WOLLONGONG LOCAL PLANNING PANEL ADDENDUM REPORT | 23 February 2024

DA No.	DA-2023/358
Proposal	Residential - demolition of existing dwellings and associated outbuildings, remove six (6) trees, construction of multi-dwelling housing - six (6) units and Subdivision - Strata title - six (6) lots
Property	11 and 13 St Johns Avenue MANGERTON
Applicant	Infinite Designs
Responsible Team	City Centre Major Development Team
Development cost	\$2,000,000
Lodgement date	3 May 2023
Prior WLPP meeting	5 December 2023

Assessment Report and Recommendation

Figure 1: Ground floor

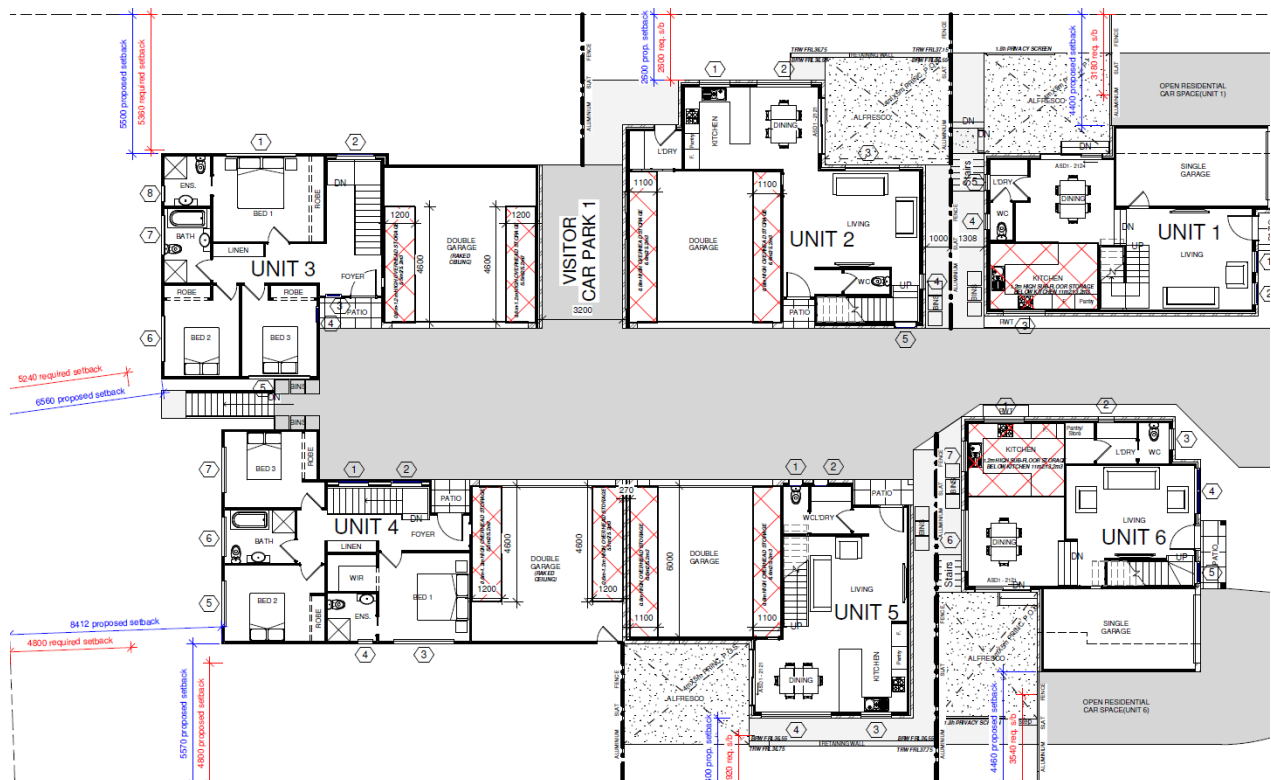
1. Setbacks to side boundaries should comply for all units;

Response: The setbacks for units now comply with the DCP controls as highlighted in red below and on plans A09b and A09c.

Location	Required (0.8 x ceiling height)	Proposed
Western elevation (first floor)		
Unit 1	$7.2\text{m} \times 0.8 = 5.8\text{m}$	5.8m
Unit 2	$6.4\text{m} \times 0.8 = 5.1\text{m}$	6m
Unit 3	$6.7\text{m} \times 0.8 = 5.4\text{m}$	5.5m
Eastern elevation (first floor)		
Unit 4	$5.8\text{m} \times 0.8 = 4.6\text{m}$	5.7m
Unit 5	$6\text{m} \times 0.8 = 4.8\text{m}$	5.57m
Unit 6	$6.7\text{m} \times 0.8 = 5.36$	6m

A07

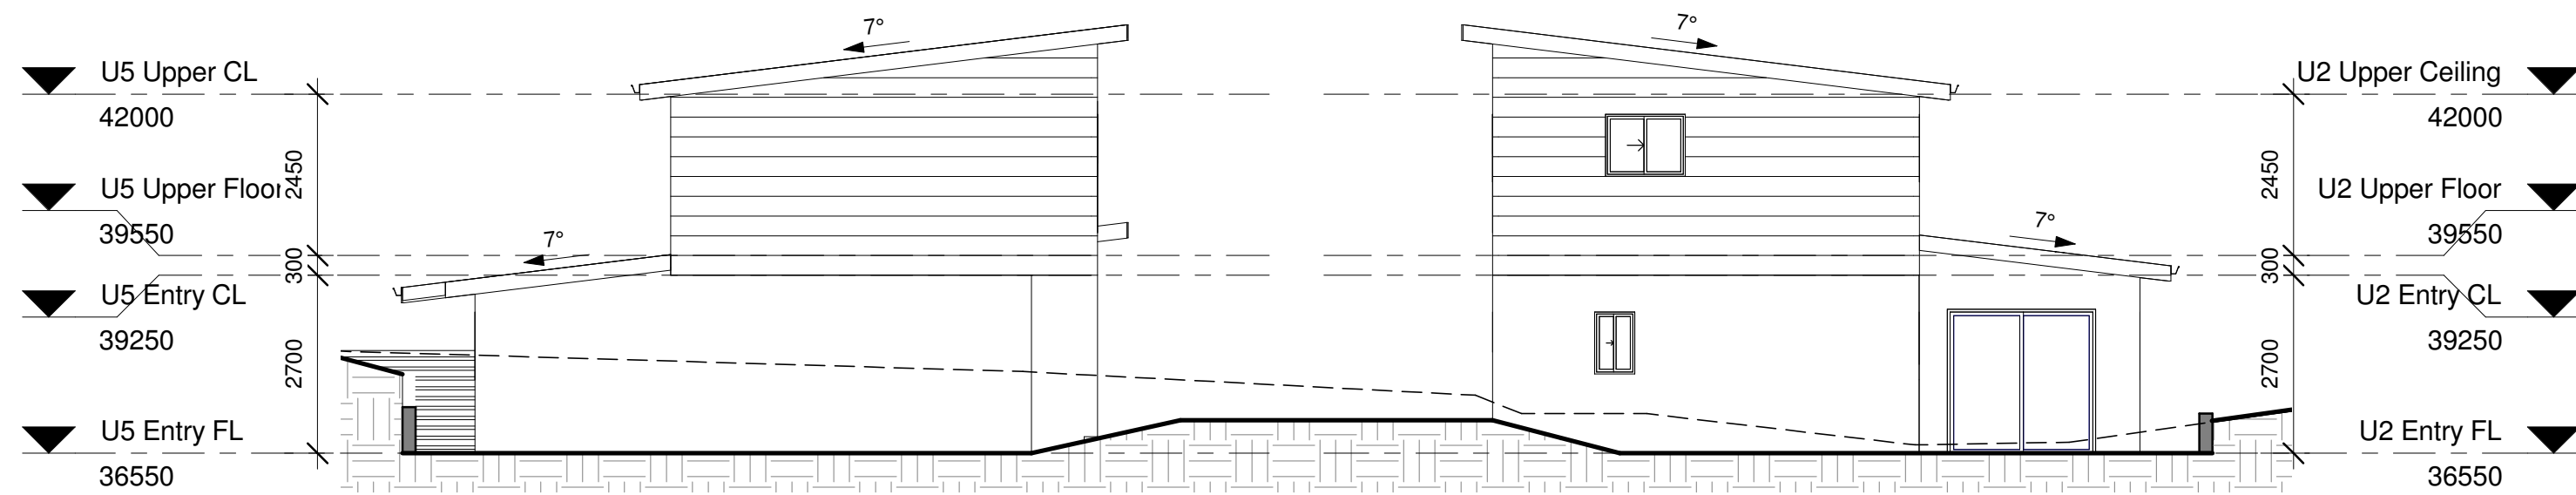
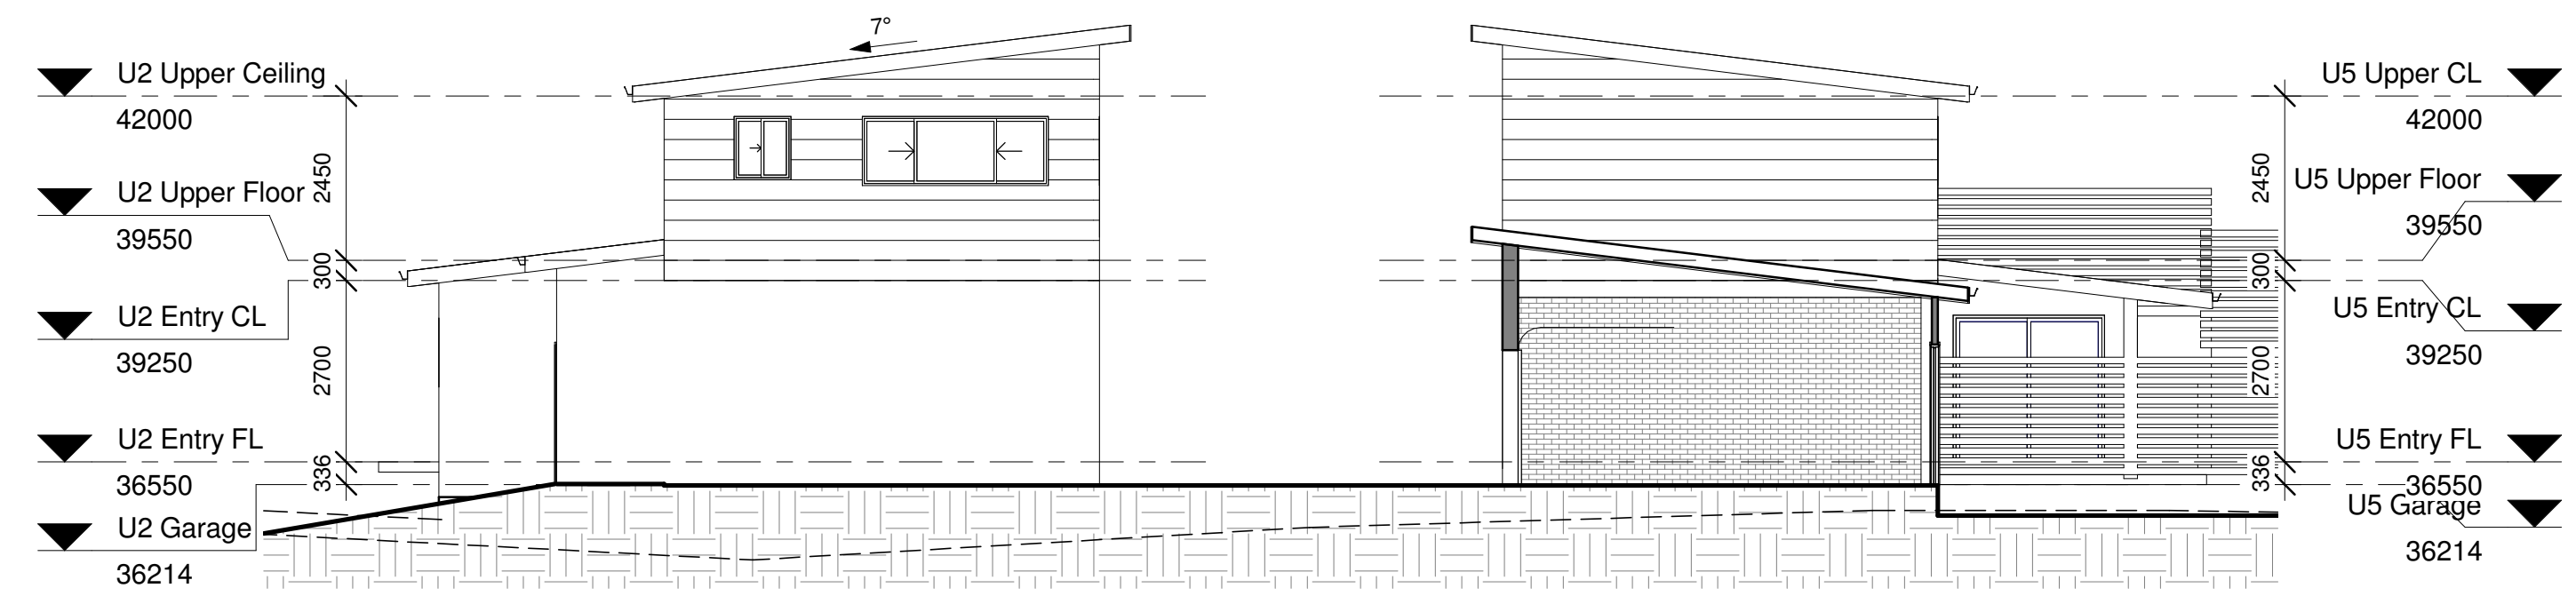
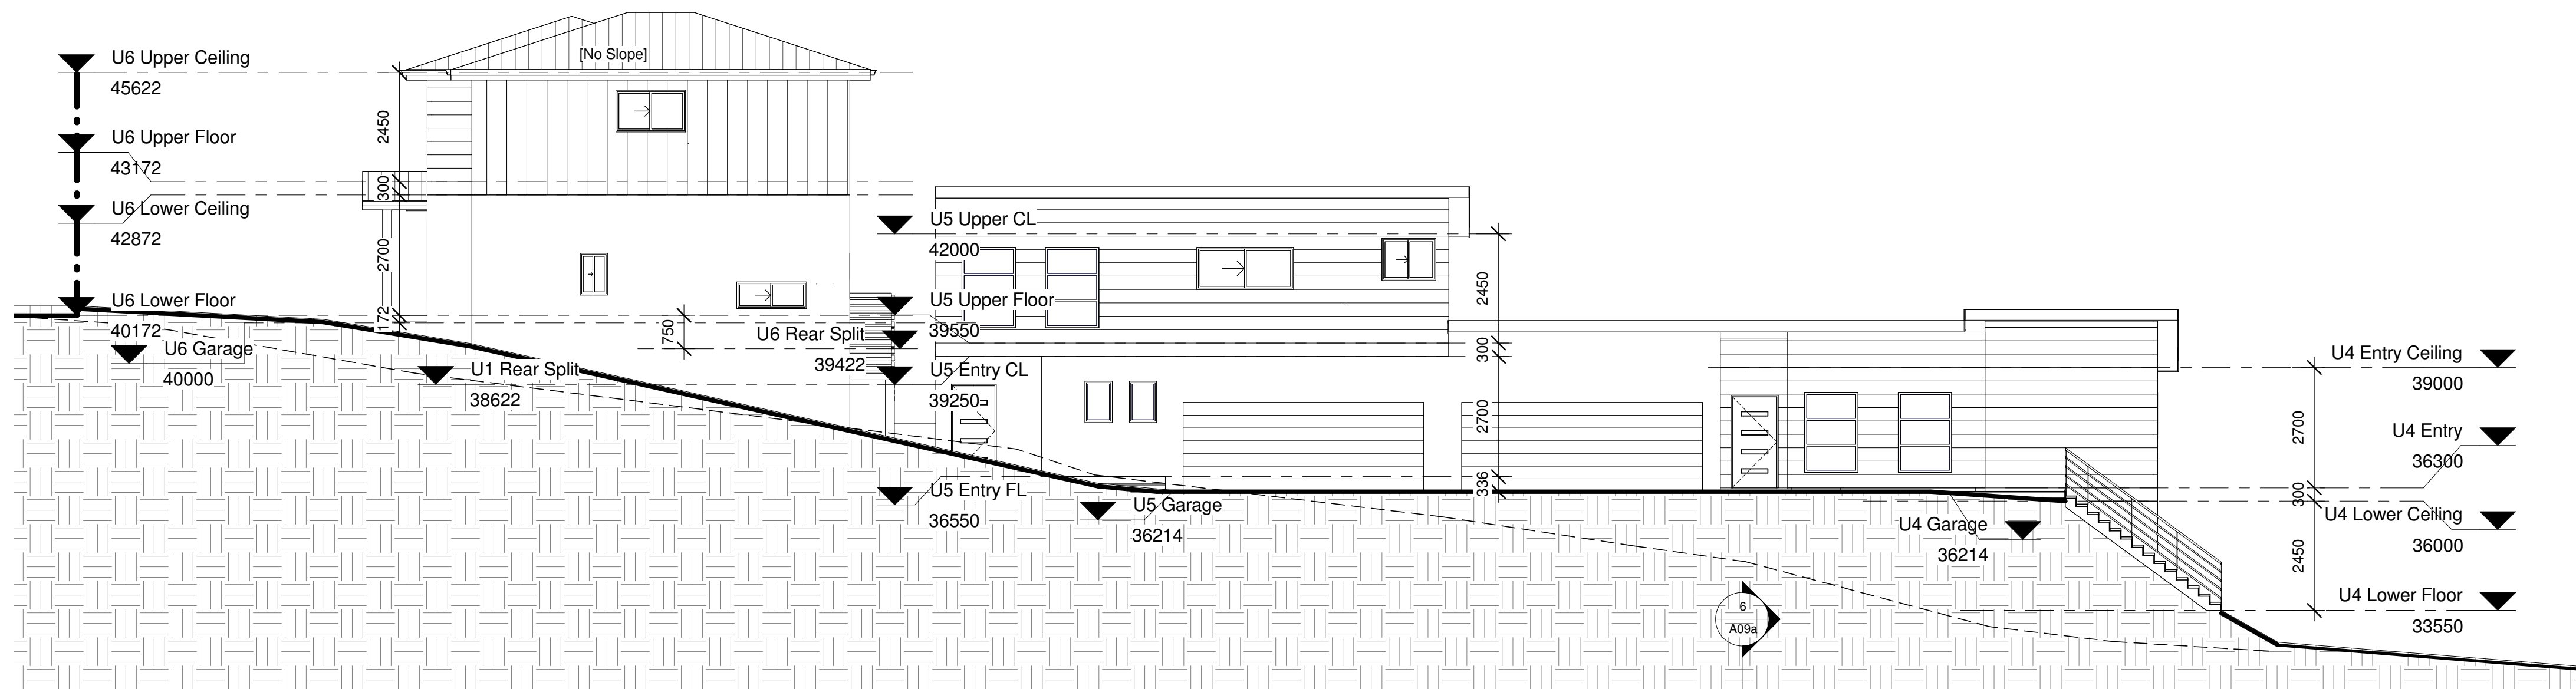
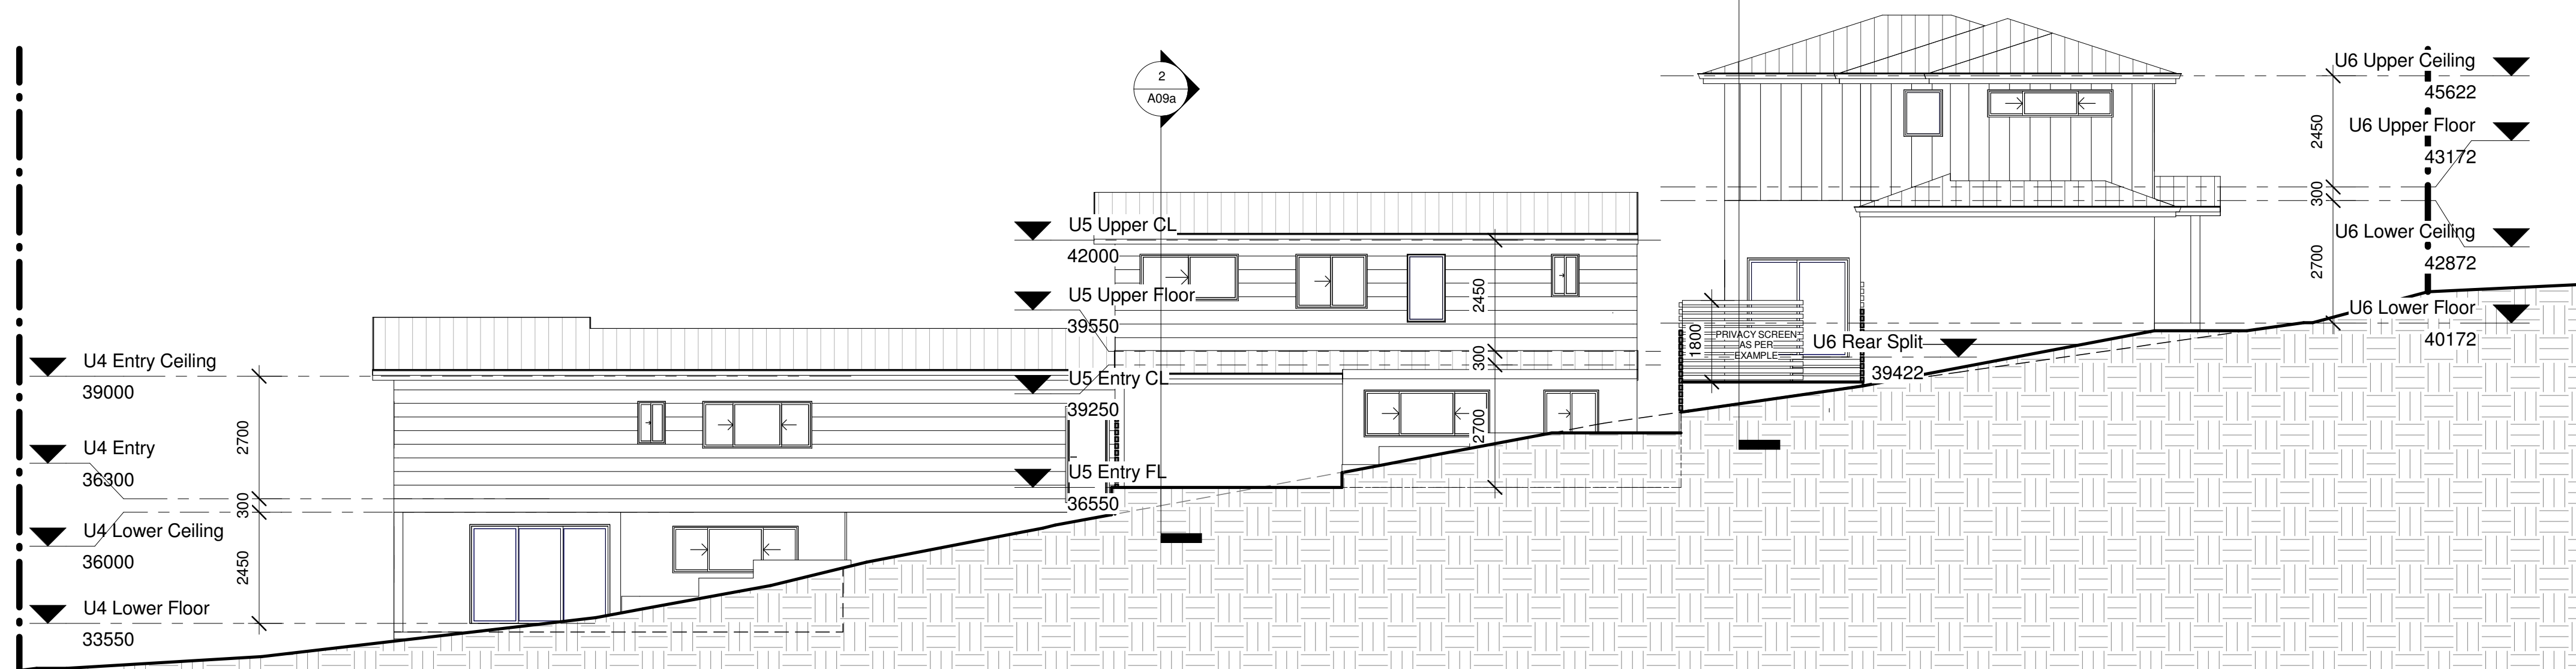
3. Consider the need for privacy screens to private open space rather than low balustrades to improve privacy impact.

Where private open space areas sit above natural ground level, they are provided with privacy screens as illustrated on plans A07 (Units 1 and 3) and A08 (Units 4 and 6).

Response: Balustrades are nominated to be powder coated aluminium (Plan reference A09a) and heights are stipulated on elevations (plan reference A07).
